Advanced LIGO Engineering Change Request (ECR)

ECR Title: ECR: Add black glass panels to the OMC Suspension Assembly to mitigate stray light noise

DCC No: E1500042-v1

- Systems Scientist
- Systems Engineer
- Deputy Systems Engineer

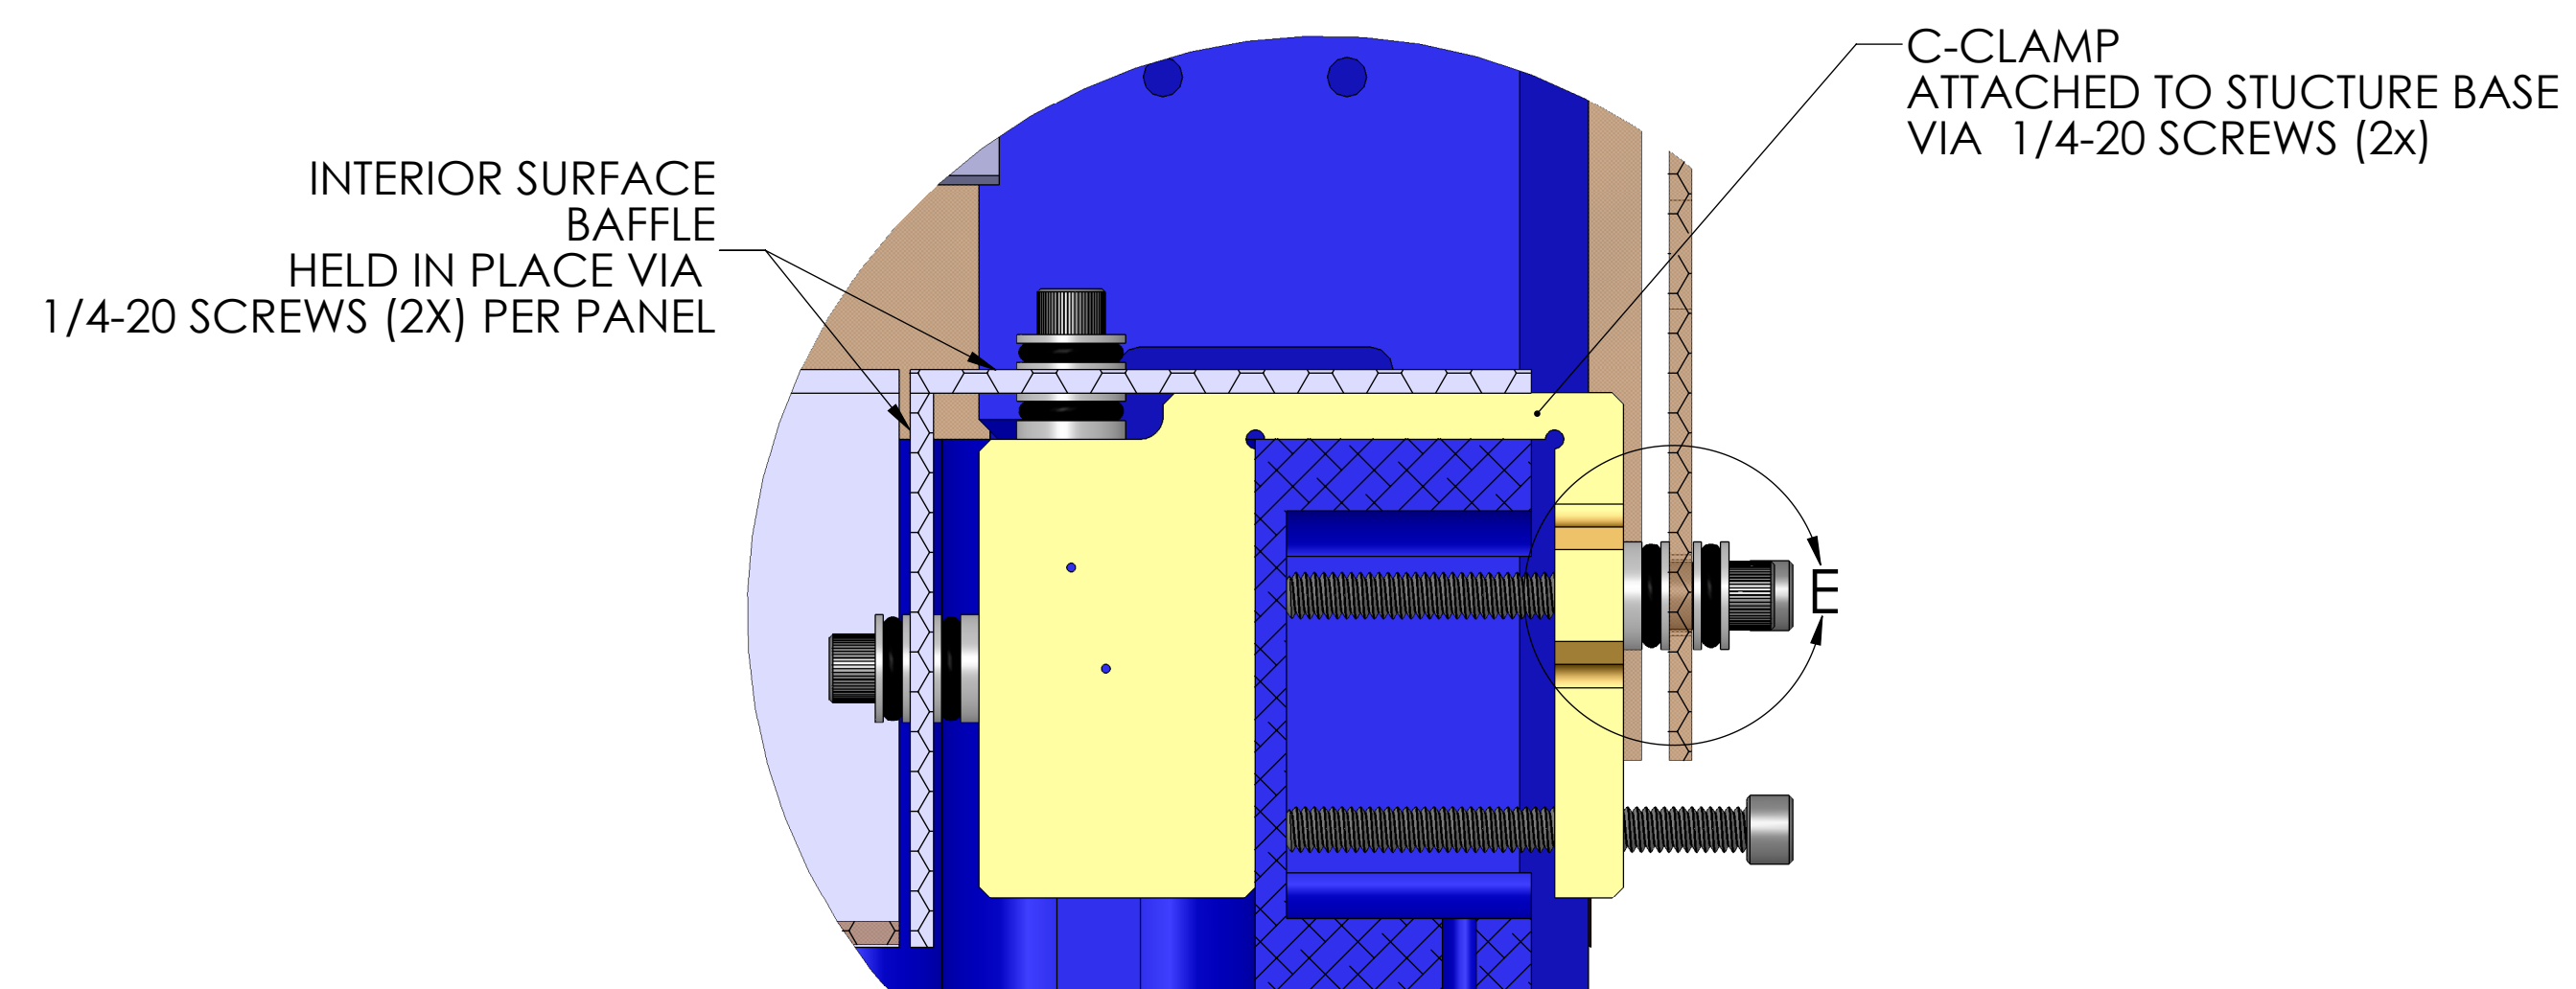
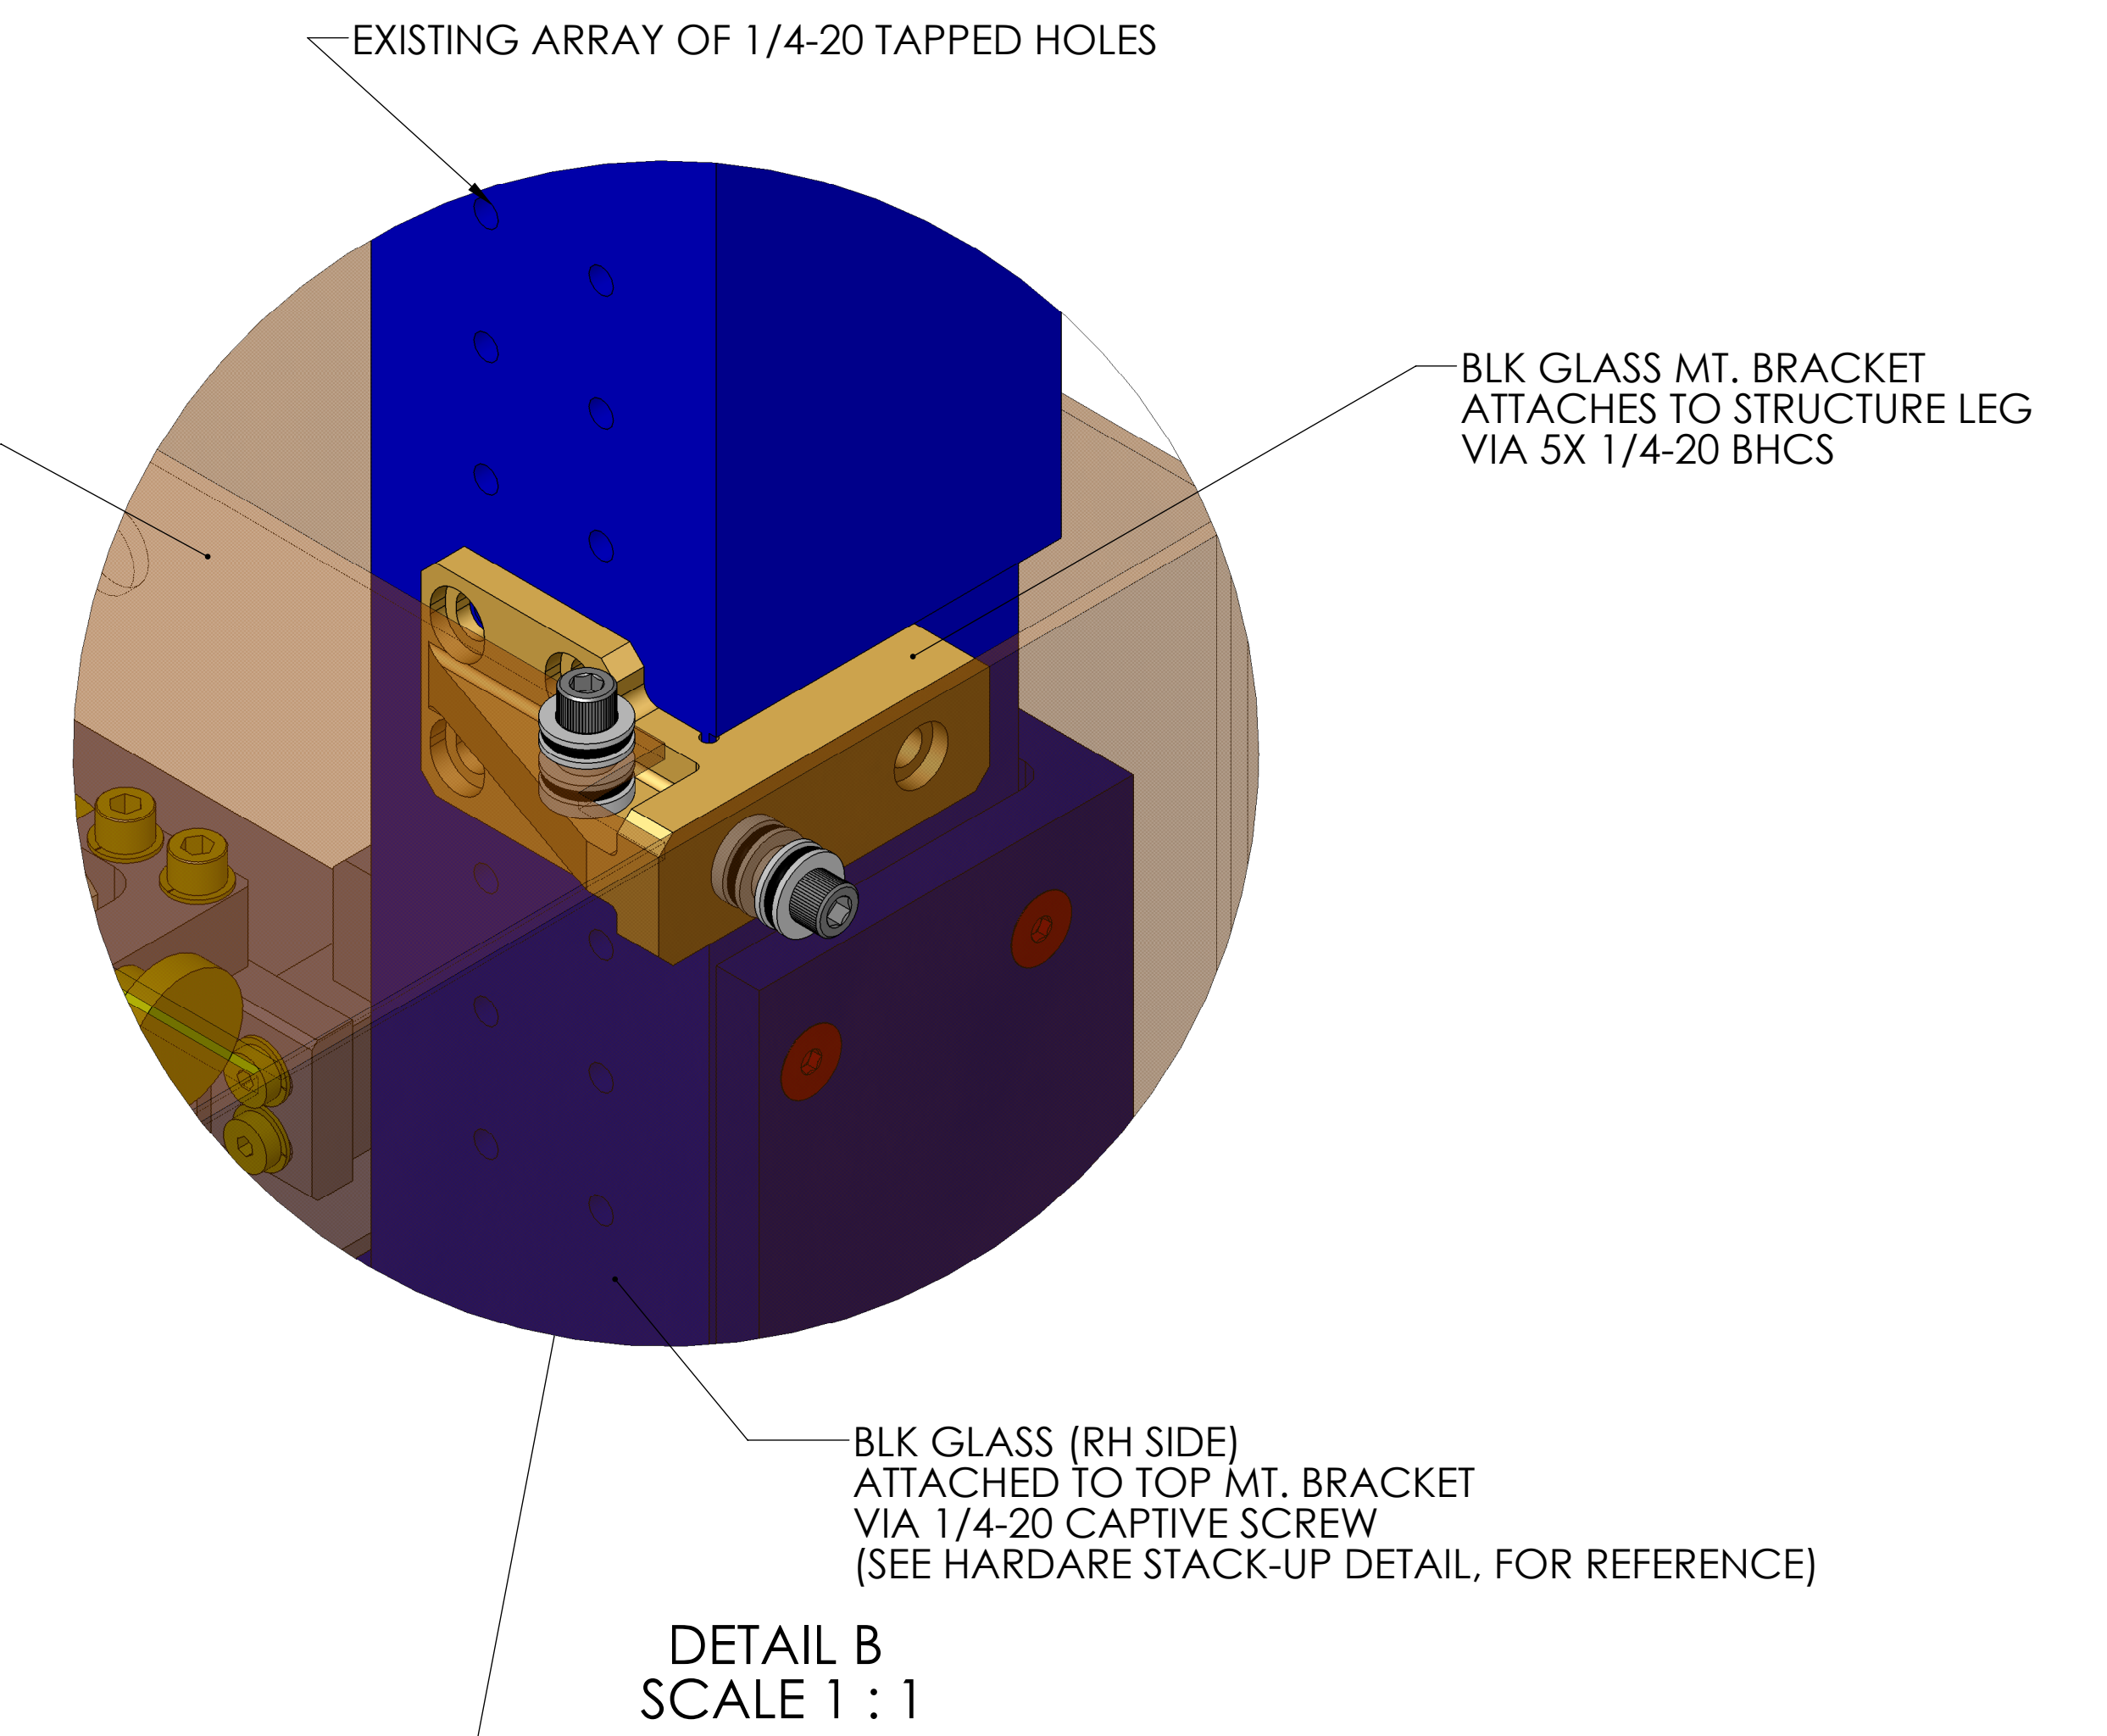
Description of Proposed Change(s): Attach AR-coated black glass panels to the OMC suspension structure (and to the optics table beneath the OMC suspension) in order to surround and isolate the OMC from scattering paths to/from the vacuum enclosure and the reflective metallic surfaces of the optics table and the OMC.

Reason for Change(s): DARM noise has been shown to increase when acoustic noise is increased/generated around the HAM6 chamber, implying a path for scattered light noise to/from the OMC involving the HAM6 vacuum enclosure surfaces (chamber walls, viewports and/or septum plate). It is reported in LLO elog #16255 that our current DARM noise (in the frequency range 70 to 400 Hz) might be limited by scattering from HAM6:

BLK GLASS (TOP)
ATTACHED TO TOP MT. BRACKET
VIA 1/4-20 CAPTIVE SCREW
(SEE HARDWARE STACK-UP DETAIL, FOR REFERENCE)
